Access Compliance Report

Public Rights-of-Way

Intersection ID: 17550	Main Street: TANGLE_DR	Cross Street: WINDEMERE_LN	Location: E
ADA ID: 4DEF41B141E8	Ramp Type: BlendTrans1	Initial Pass/Fail: Pass	Overall Compliance: No
		Severity Score: 11.5

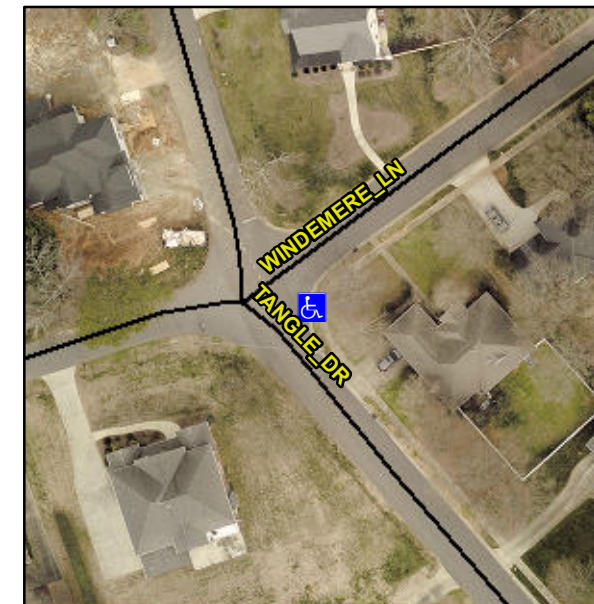
Remove & Replace Curb Ramp With Two New Directional Ramps or Equivalent. Remove & Replace Gutter.

Not Found, R304.2.1, R305.1.4, R305.2, R304.5.4, R304.5.3
